1. MODIFICATION OF THE FRONT ENCLOSURE IN THE LOADING/UNLOADING ZONE (RACKER AND DERACKER)

2. AMBIENT HUMIDITY CONTROL SYSTEM FOR CURING

3. REDUCTION OF CURING TEMPERATURE DIFFERENCE BETWEEN TILES

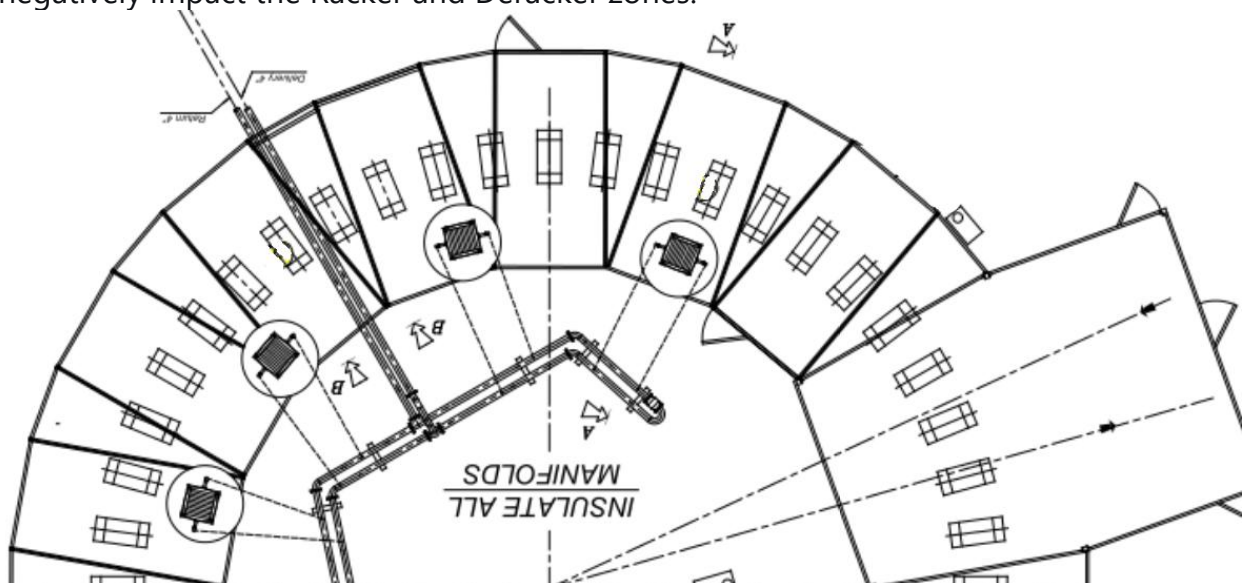
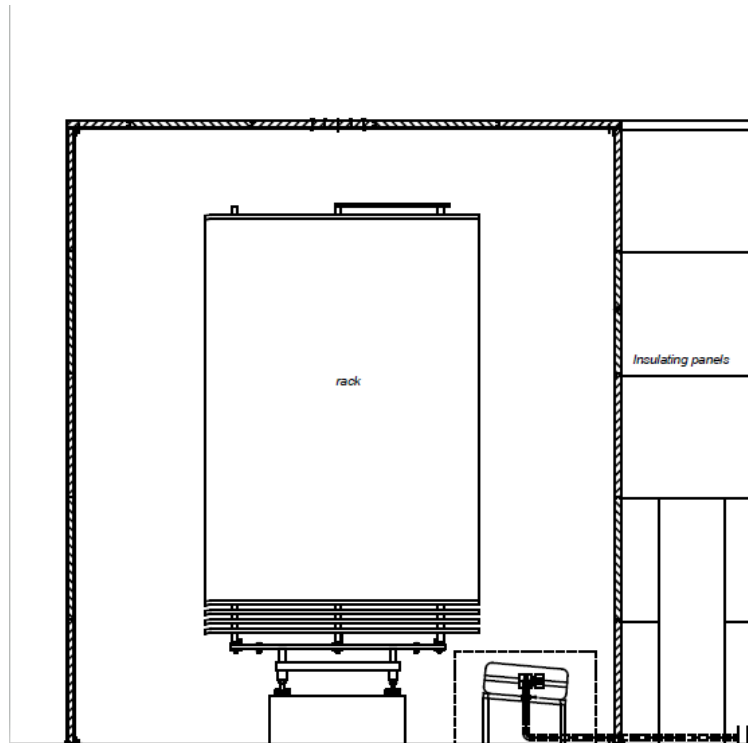
- The Racker and Deracker areas are located within the ROTARY's internal enclosure, sharing the same ambient air as the curing chamber.

- As a result, temperature and humidity spikes during tile loading directly and negatively impact the Racker and Deracker zones.

- The current setup allows visibility into the ROTARY's interior from the lateral access points of the Racker and Deracker.

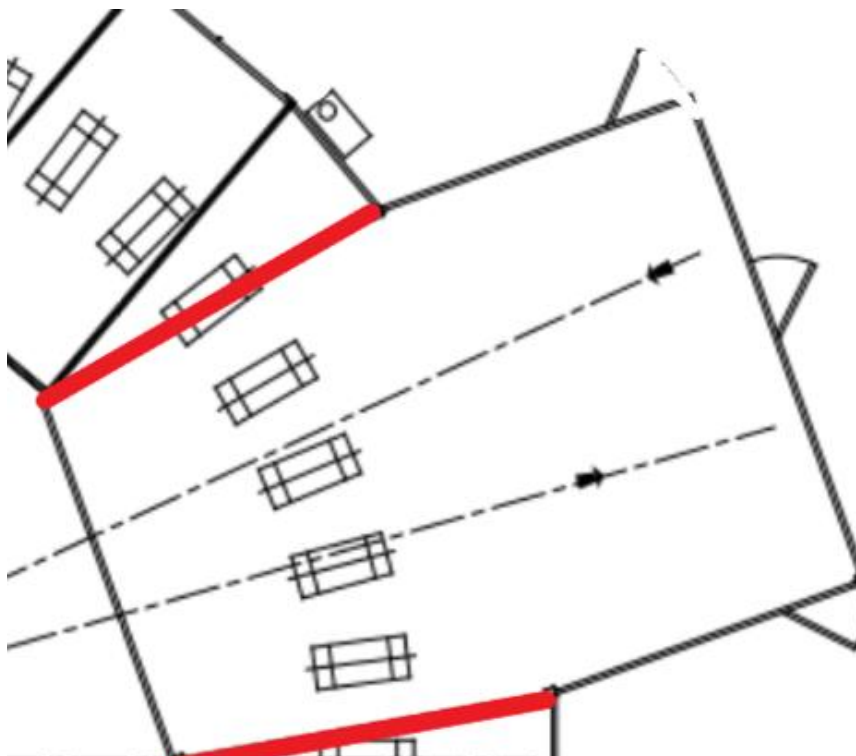
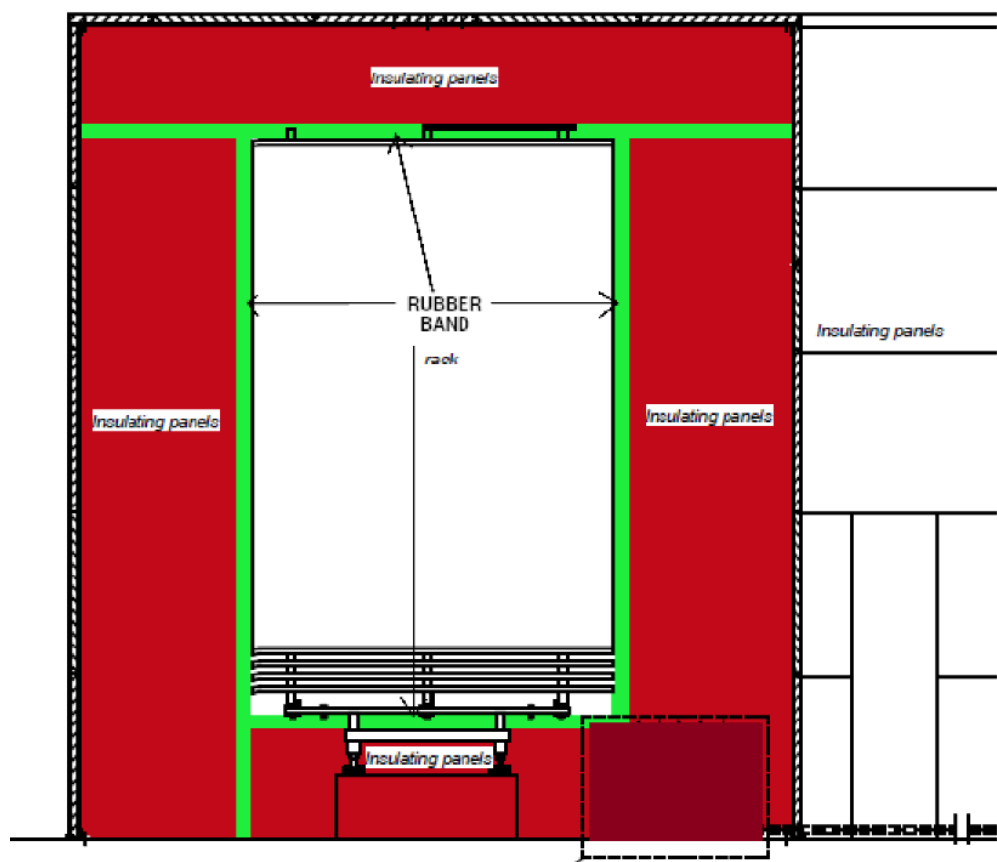
To eliminate the existing external enclosure, the following steps are proposed:

1. Install insulating panels in the interior areas defining the enclosure.

2. Incorporate rubber seals on the top and sides of the insulating panels to improve sealing.

3. Optionally, include access doors in the panels for maintenance purposes.

4. Once the interior enclosure is completed, proceed with the removal of the external front and side panels.

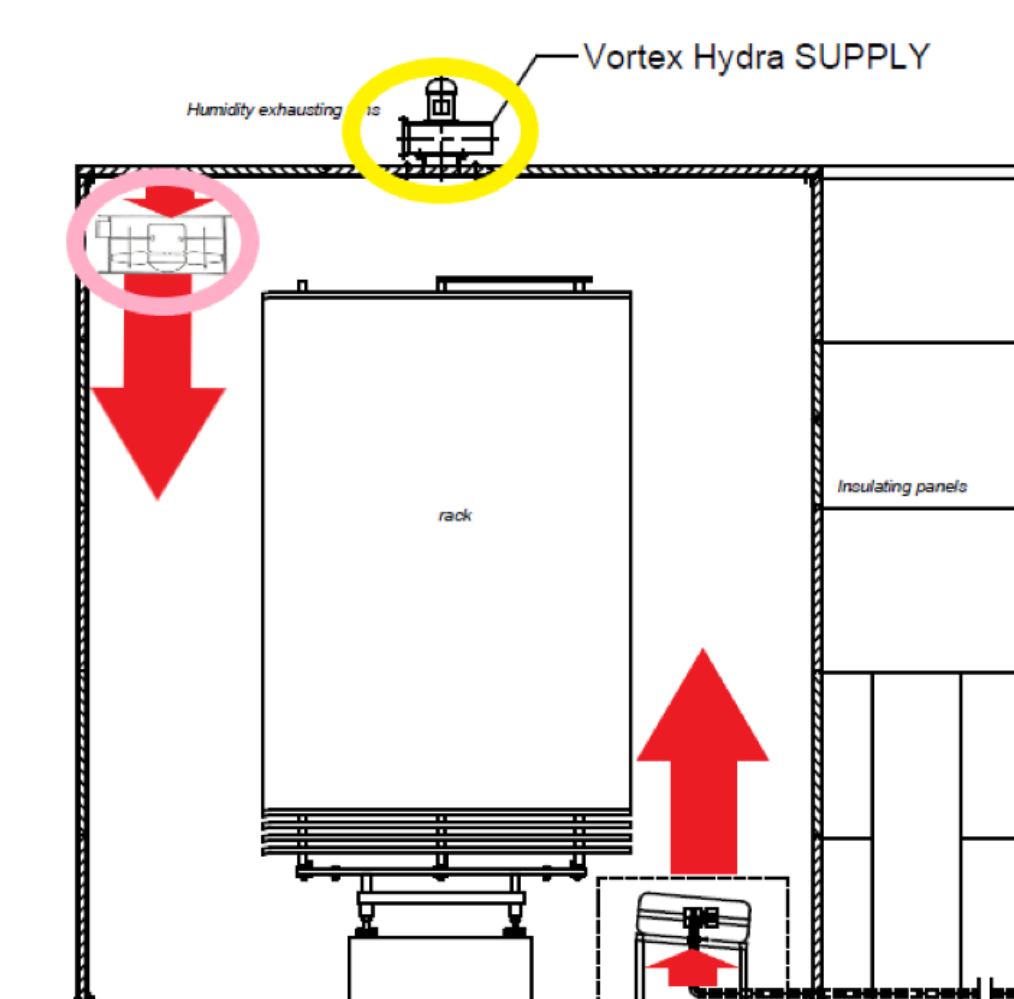
A temperature difference of approximately 15°C has been identified between the upper and lower zones of the ROTARY curing system. This variation causes significant discrepancies in tile finish, with higher gloss on the upper tiles and darker shades on the lower ones.

To homogenize the temperature inside the chamber, a forced air recirculation system is proposed. The strategy involves redirecting hot air from the upper zone to the lower levels of the ROTARY.

The proposed solution includes the installation of two recirculation fans strategically placed in front of the existing heat exchangers. This design will:

- Force the descent of accumulated hot air from the upper section.
- Ensure constant and uniform air circulation throughout the chamber.
- Maintain even thermal distribution during the curing process.
